WARRANTY BULLETIN

Wb04-16

DATE : DECEMBER 2004	SECTION : 07 - Transmission
EXPIRATION: DECEMBER 2006	
SUBJECT: MODIFICATION OF SPEED SENSOR CONNECTORS ON ALLISON WORLD TRANSMISSION

Figure 1: LOCATION OF THE CONNECTORS ON THE TRANSMISSION HOUSING

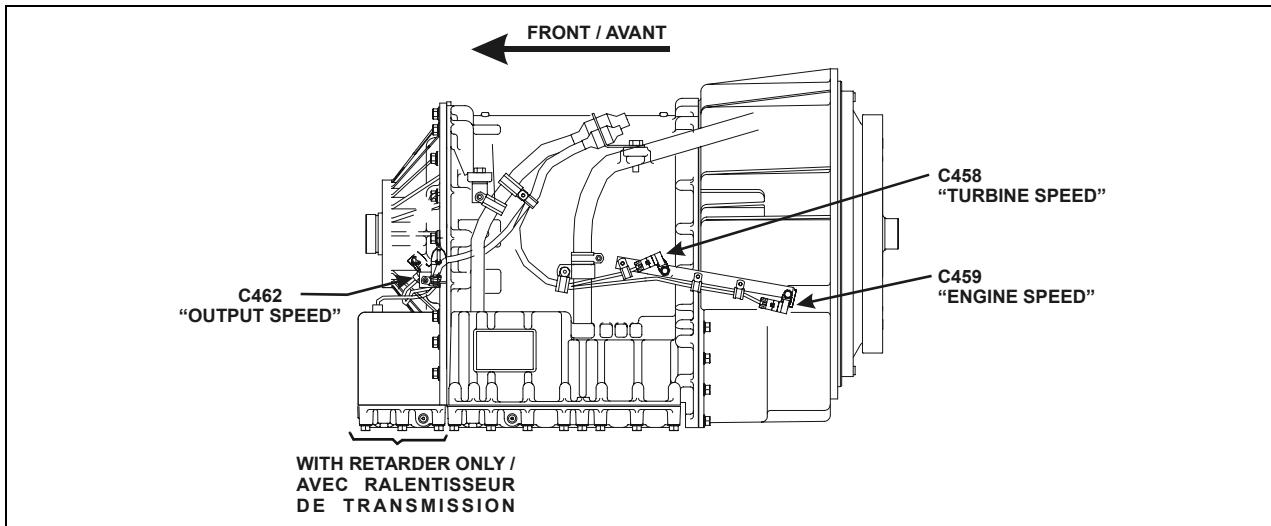
1. Using figure 1, locate the 3 speed sensor connectors which have to be modified (on transmission housing, left side of vehicle): C458 "TURBINE SPEED", C459 "ENGINE SPEED", C462 "OUTPUT SPEED".

Figure 2: MODIFICATION OF THE CONNECTORS

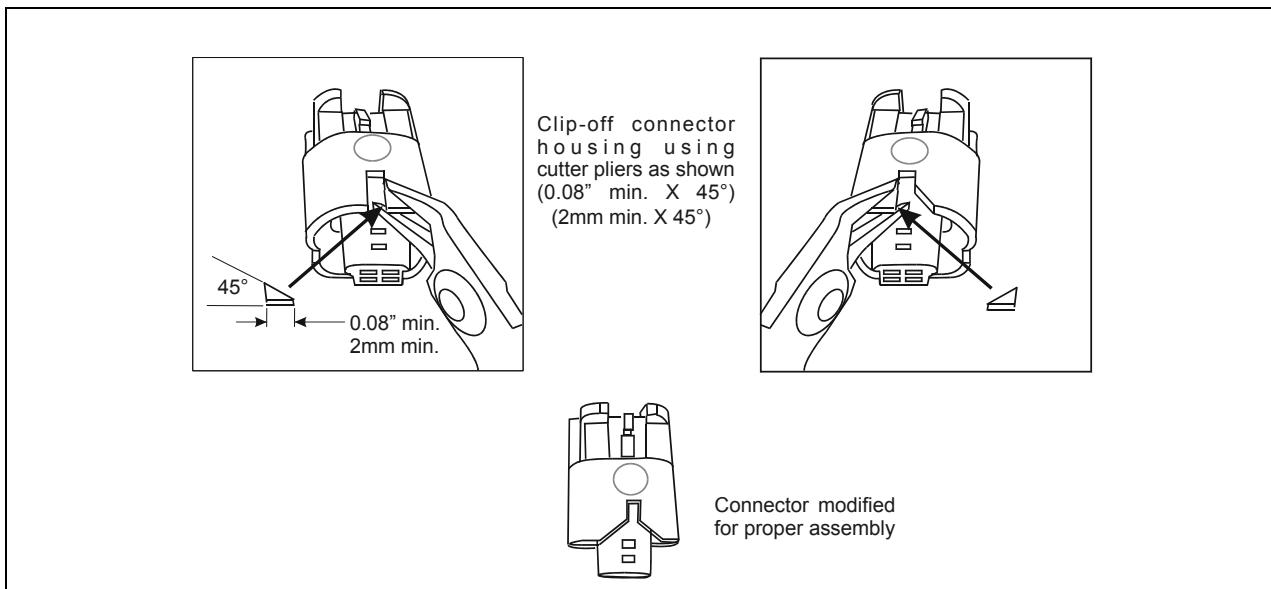
Allison, manufacturer of the World B500 transmission advised Prevost Car that a problem with the speed sensor connectors could happen. The connectors can unplug from the transmission housing or become loose because the locking device does not engage properly. The transmission knocks when shifting or can shift to neutral when that situation happens. A vehicle breakdown can occur. These problems generate the following error codes: 22-14, 22-15, 22-16 and 22-11. **If your vehicle is equipped with a ZF-Astronic transmission, please do not consider this bulletin.**

2. Modify the connectors as shown on figure 2.
3. Plug the connectors. Assure that the connectors are perfectly locked on the transmission.
